PROJECT: Summerlin V23B Phase 1 V(Carpis + rano)

SUBMITTAL: 1st

CITY OF LAS VEGAS		DATE:
INTER-OFFICE MEMORANDUM		September 12, 2013
TO: Land Development Services Department of Building & Safety		FROM: Albert Sung, P.E. Flood Control Project Engineer Department of Public Works
SUBJECT:	Drainage Study for:	COPIES TO:
	Summerlin V23B Parcel V (Capistrano)	VTN Nevada
Cross Streets:	NEQ of Sky Vista Drive & Alta Drive	Ryland Homes Nevada, LLC
File Number:	F:\Depot\DSMemos\DS4623A.doc	Bart Anderson, P.E., DevCo
Parcel Number:	137-34-111-003	CCRFCD
Zoning Action:	TMP-50117	
FEMA Flood Zone	YES	NO X
Proposed Storm Drain	YES	NO X

The Drainage Study for the subject project has been reviewed and:

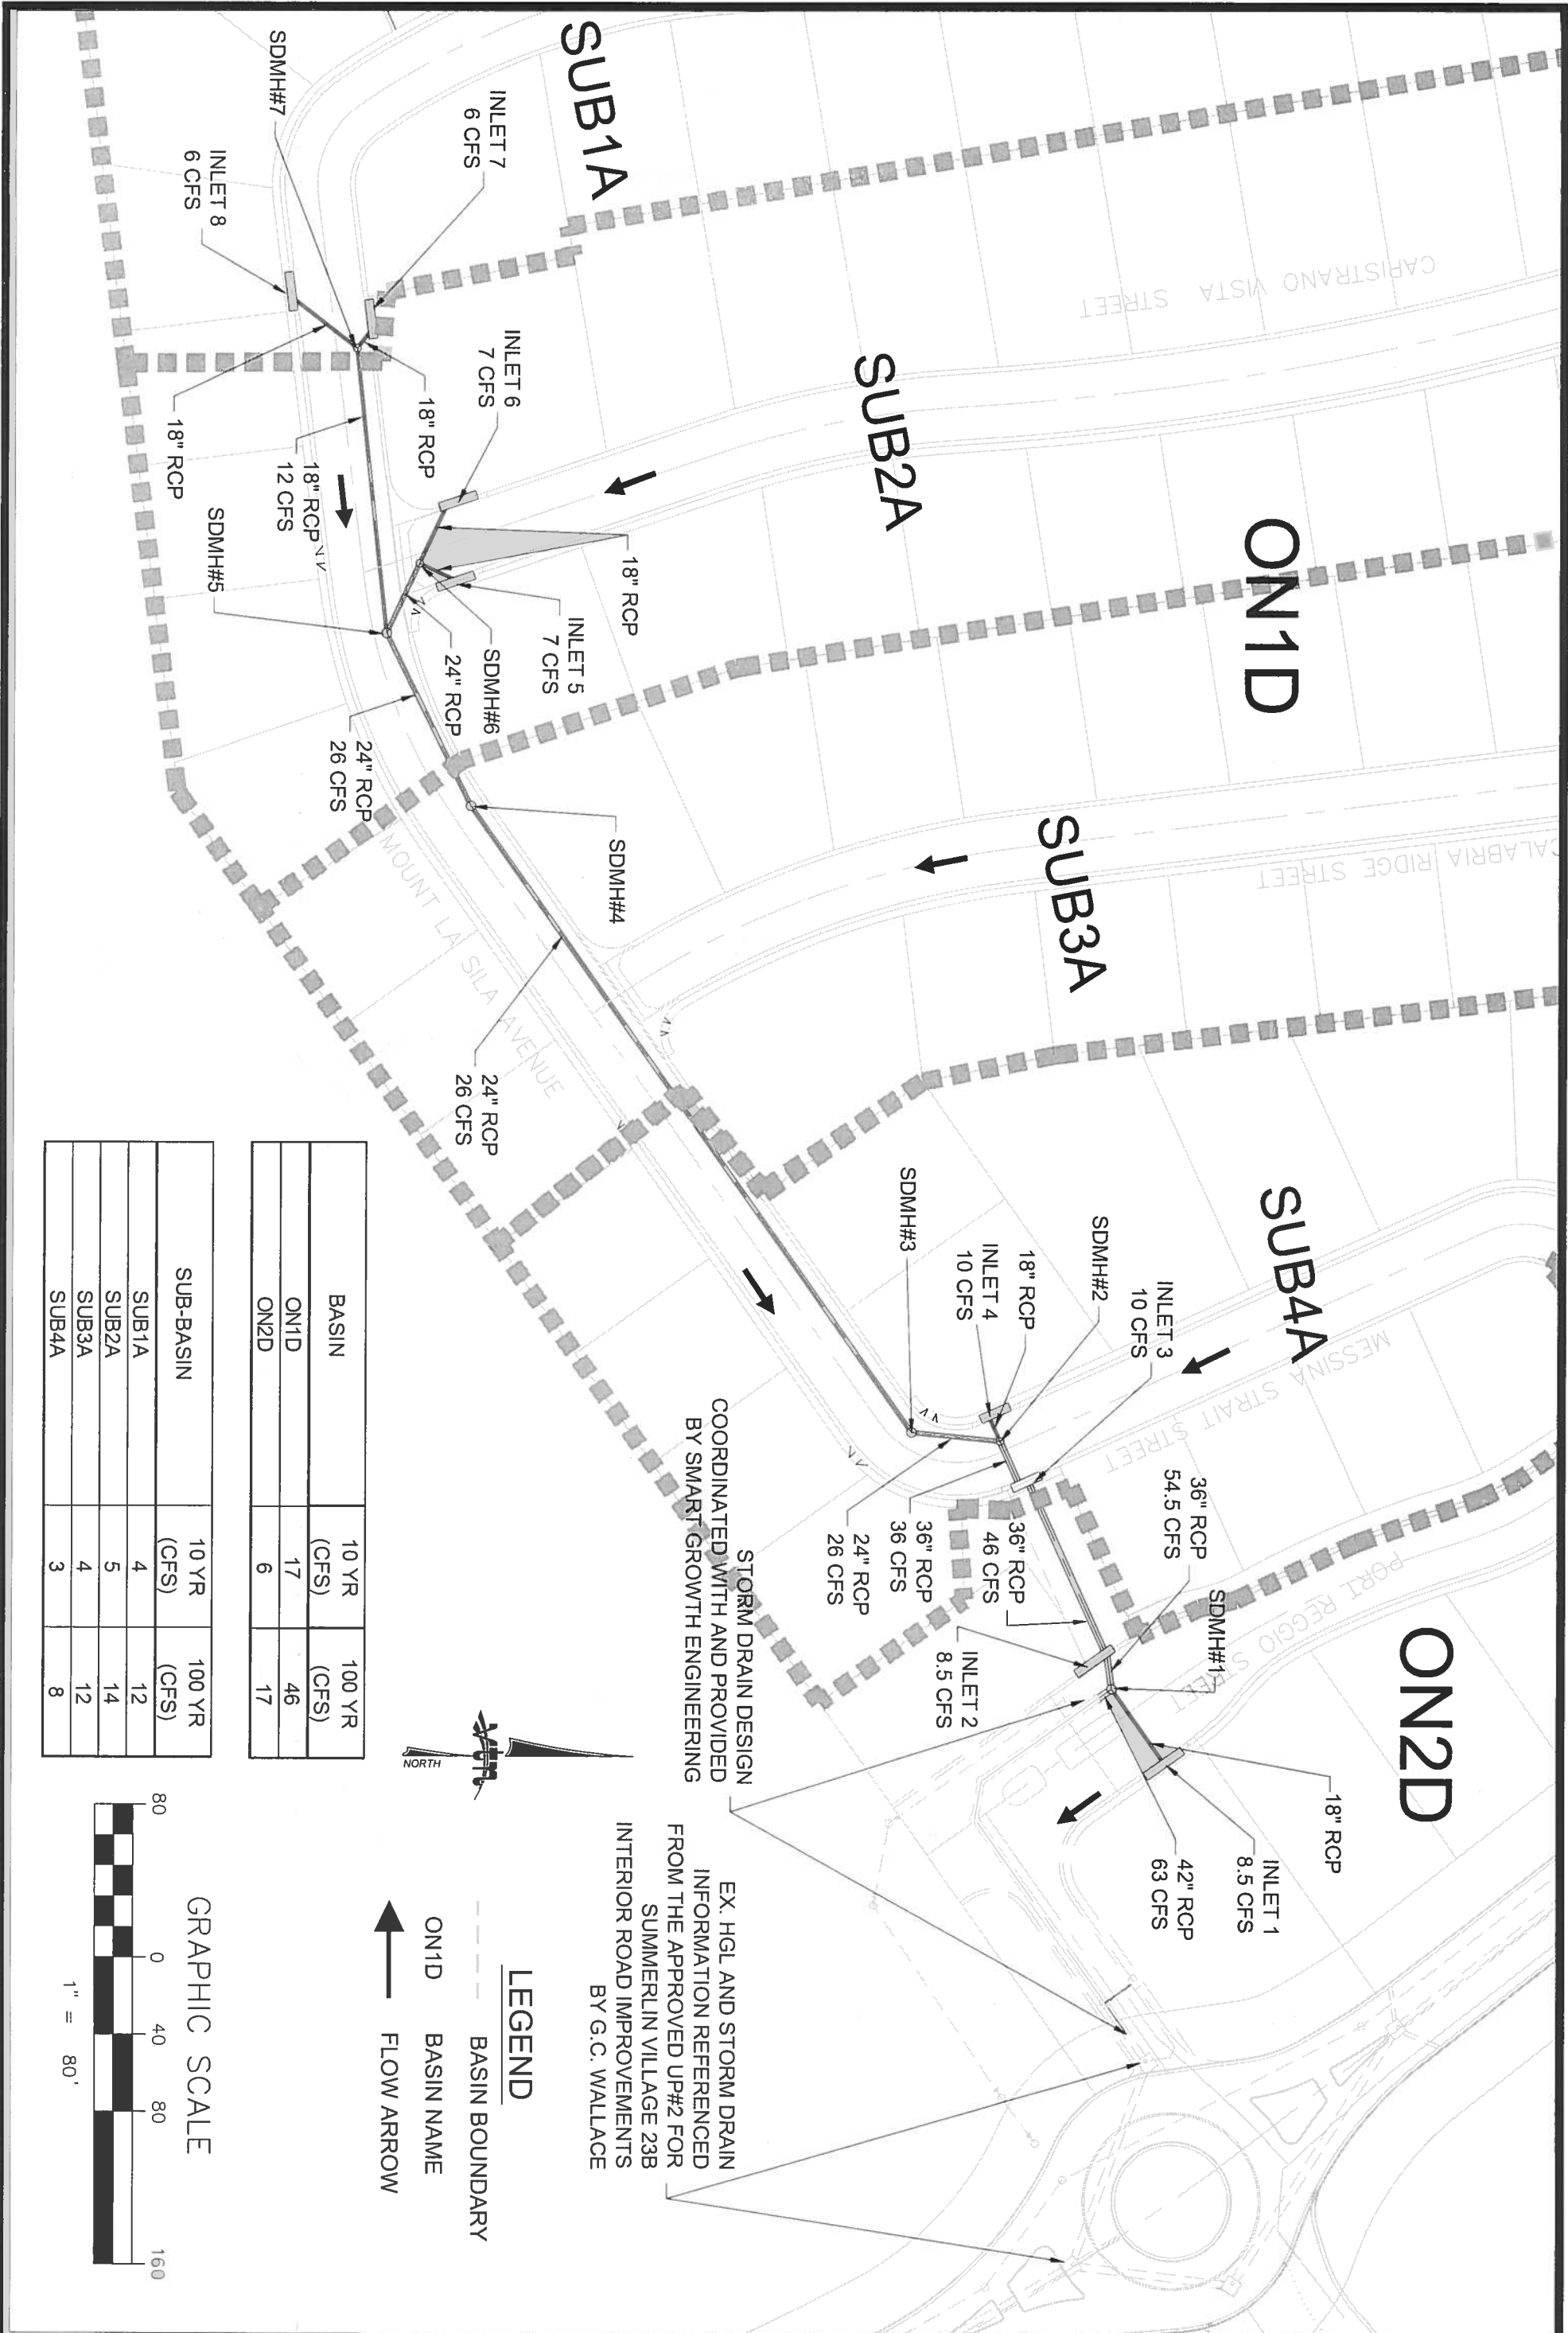
3. Comparing Page 7 of the study, **Table 2 (Street Flow Calculations Summary)** and a table in **Figure 5B**: The numbers in the two tables for *Hydraulic Section FM-1 (10-year and 100-year)* are not the same. Explain the discrepancies in the next submittal.

SHEET
GR1
OF SHEETS
DRAWING NO.

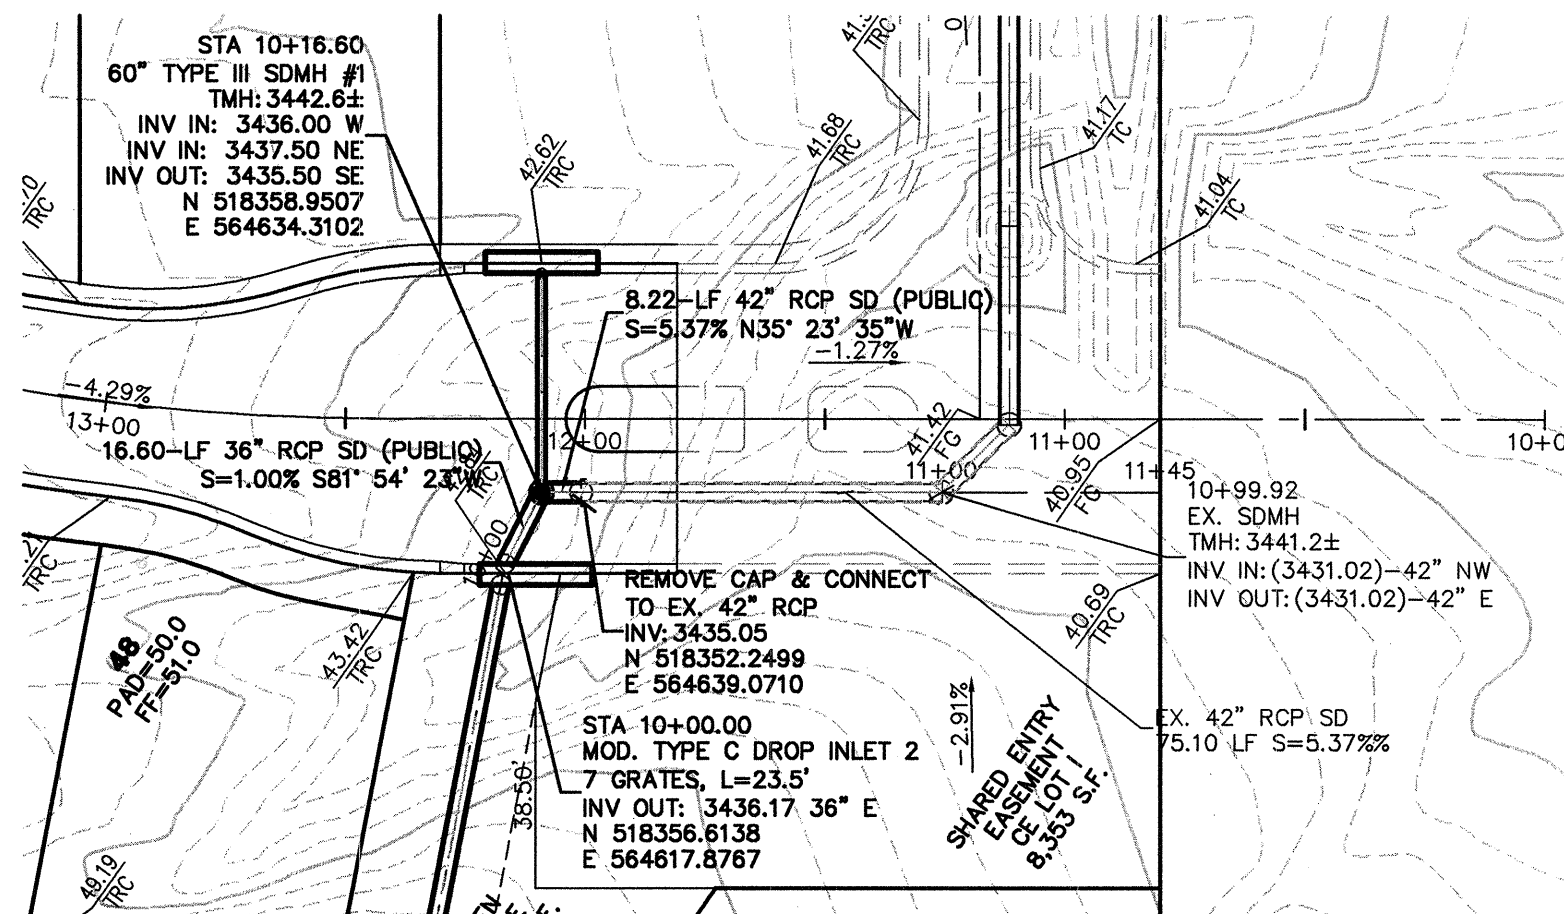
6. **Sheet GR1 & Sheet GR3:**

It appears that the finish floor elevations of the houses along *Sky Vista Drive* are lower than the adjacent street grades. The perimeter wall along *Sky Vista* must be a flood wall for protection. Revise **Details A/D1, B/D1 and C/D1** to indicate that the bottom three courses of the wall must be 8"-CMU and to be solid grouted.

DRAWN BY: DMO JULY 2013
DESIGNED BY: JULY 2013
CHECKED BY: AY
PROJECT NO: 7534
SCALE: 1"=40' HORIZ. VERT. NA
SHEET GR2 OF SHEETS
DRAWING NO.

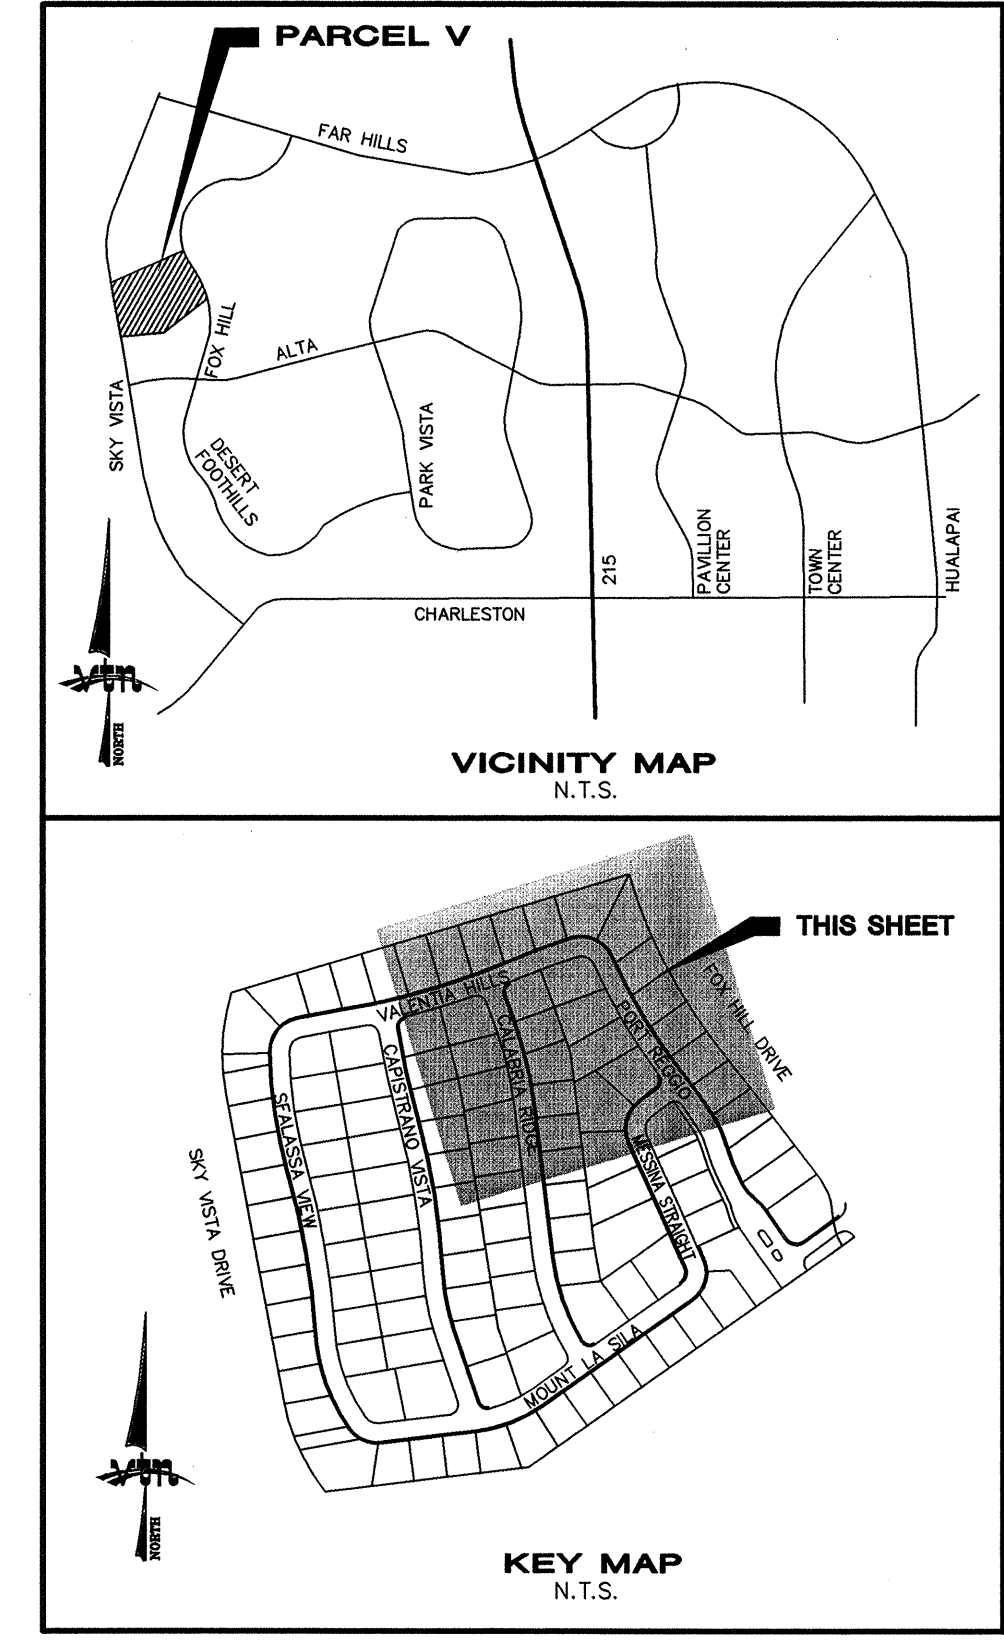
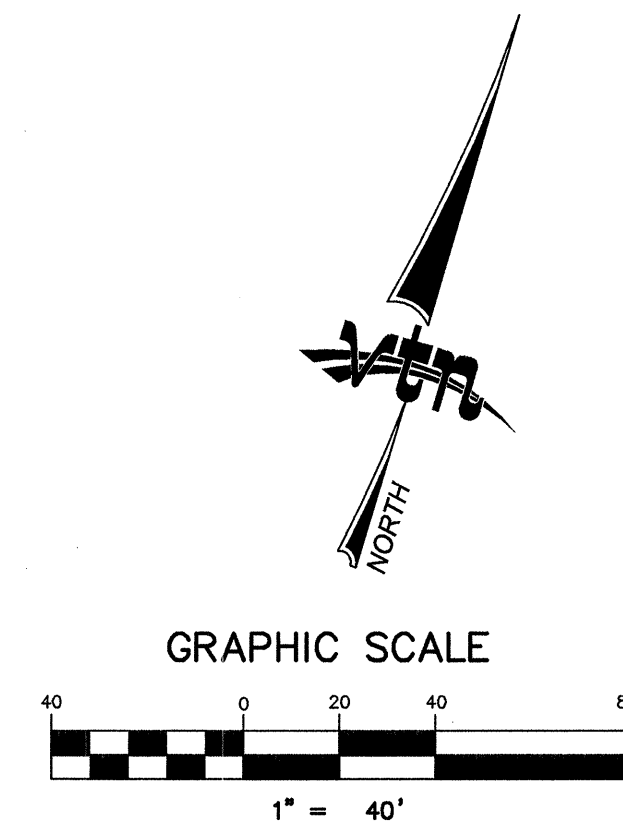
7. **Sheet GR2 & Sheet GR4:**

Label the existing storm drain system and identify all the associated facilities such as drop inlets, laterals and manholes with *City of Las Vegas* recorded drawing number on the plans.

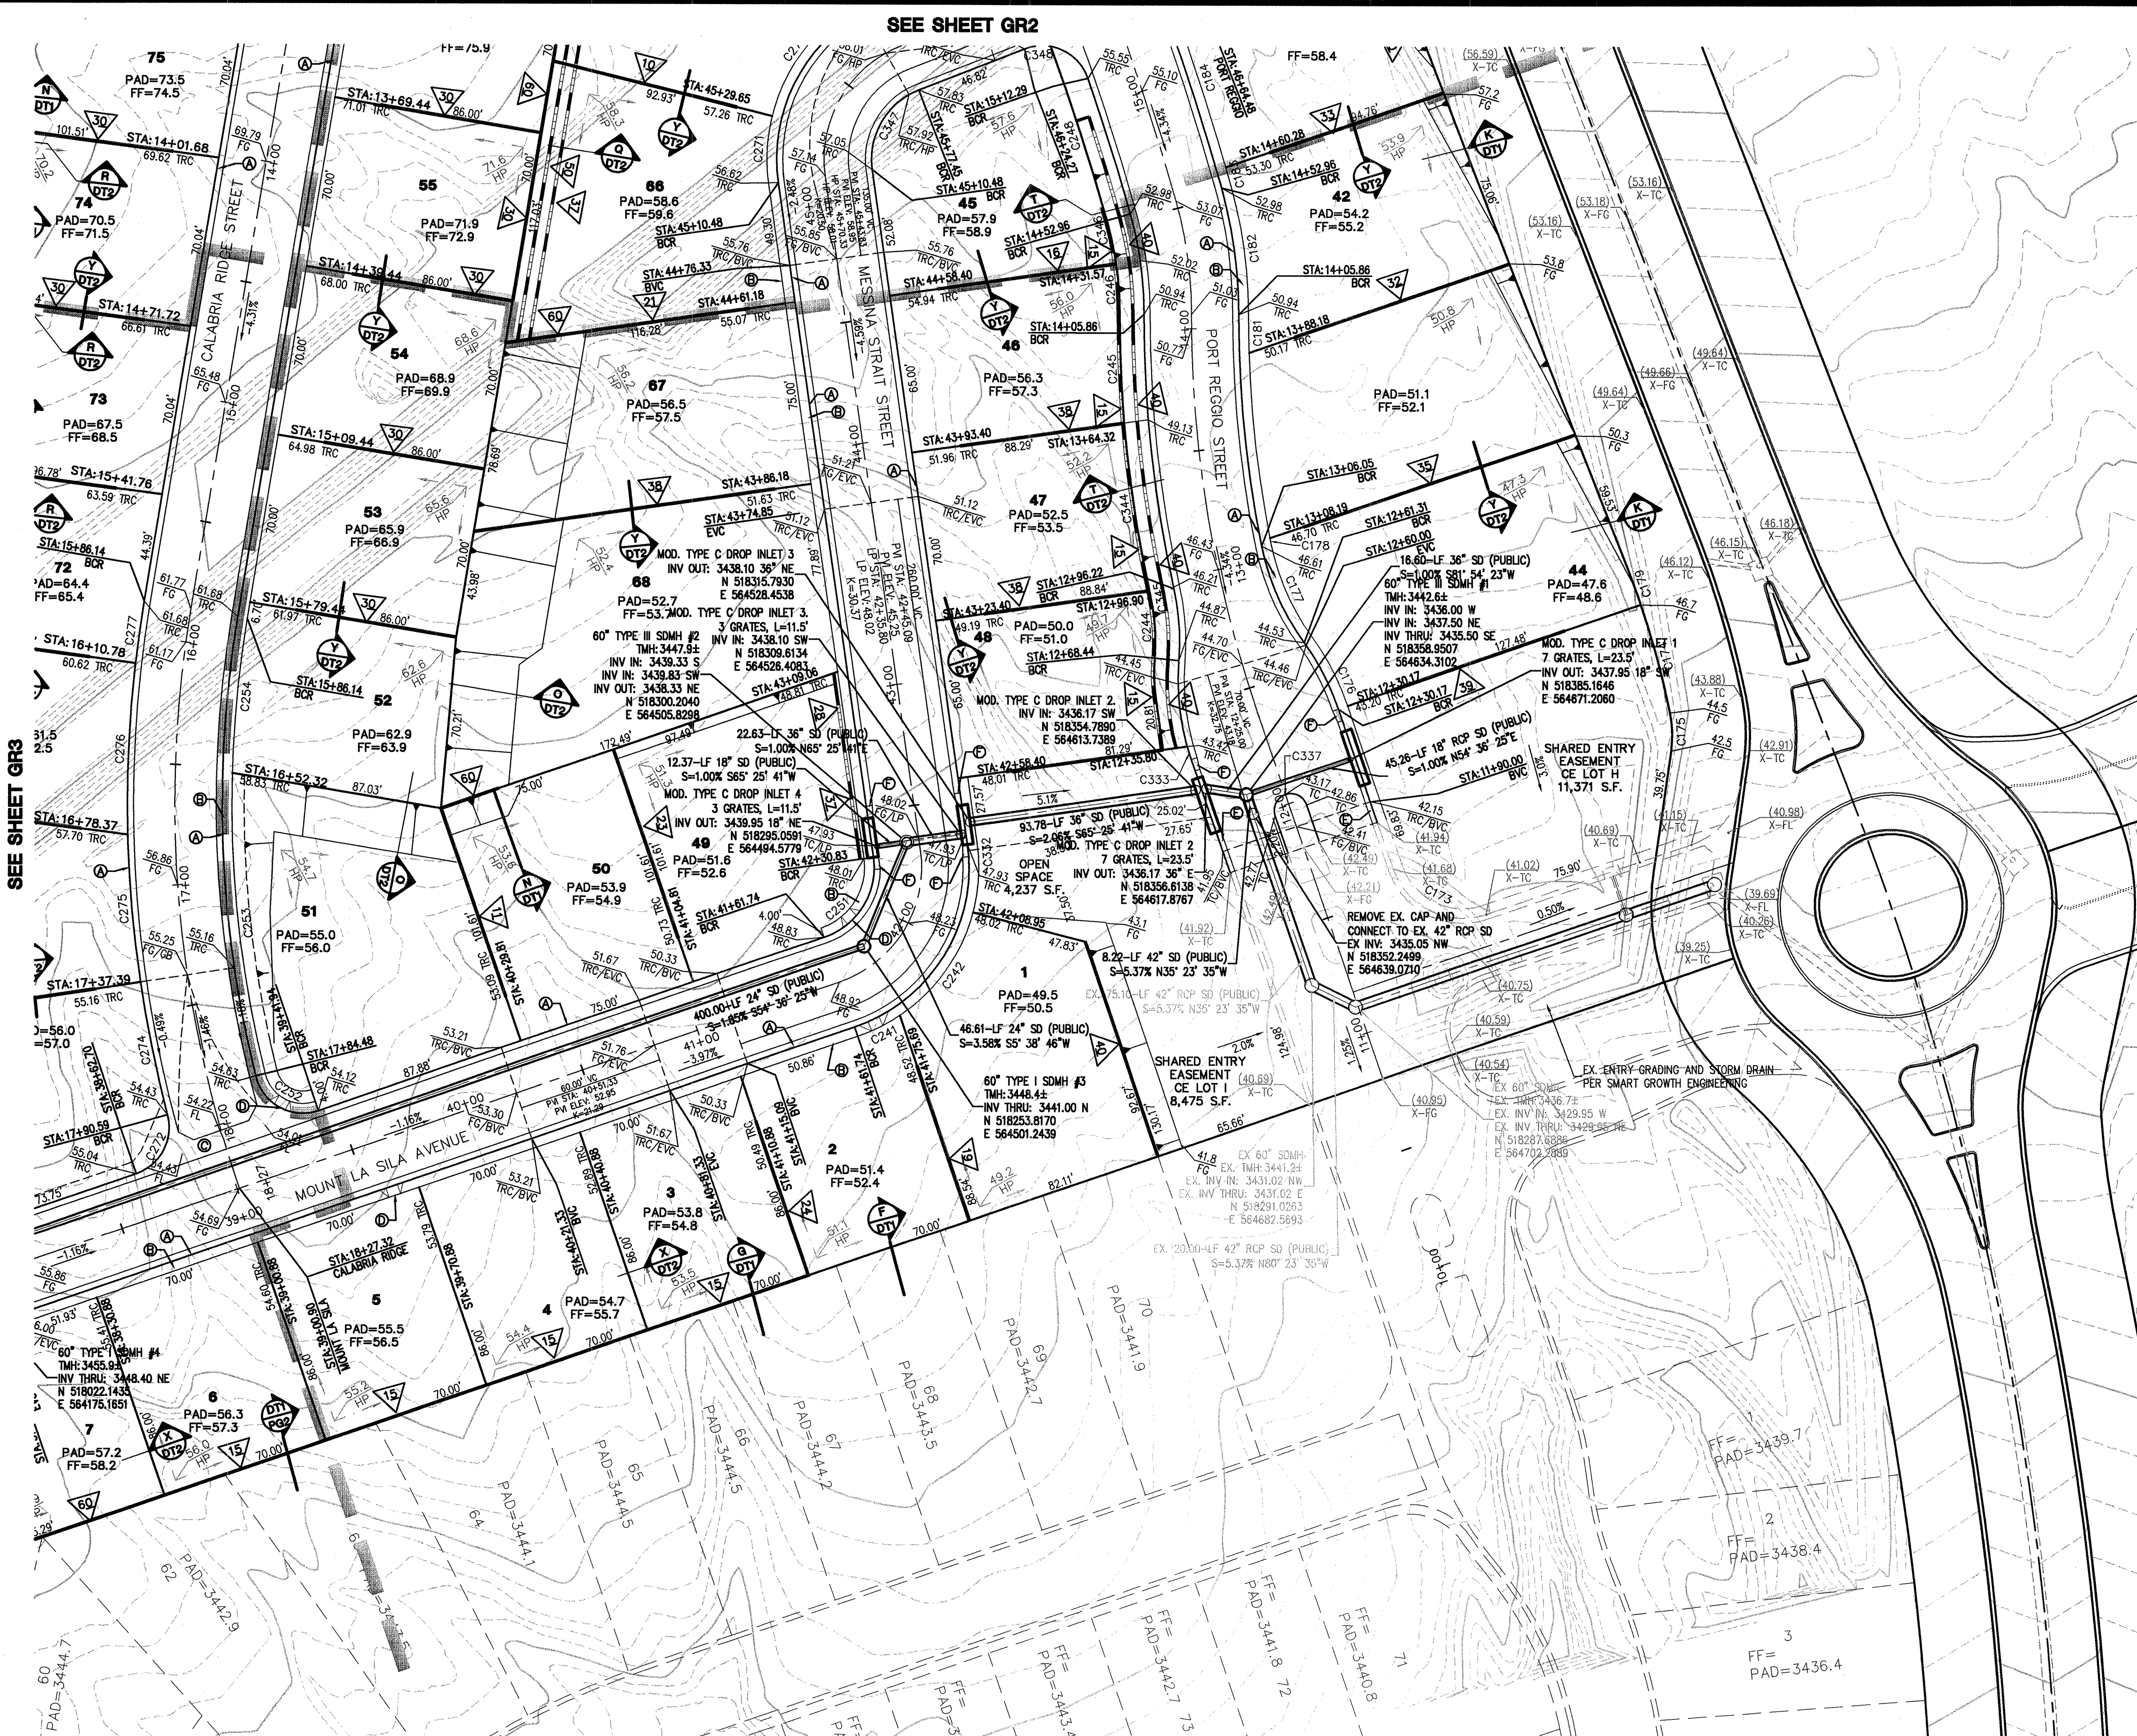
9. **Sheet GR4:**

- Two proposed storm drain inlets in *Port Reggio Street* are longer than 20' in length. Our experience is that a single more than 20'-long inlet is not hydraulically as efficient as two equivalent length inlets separated at a distance. Review and revise in the next submittal.
- Clearly identify, delineate and size of a public drainage easement (privately maintained by the HOA) between Lot 1 and Lot 48 on the grading plan. This easement must be granted as a "Common Lot" either in a Final Map or by separate document.
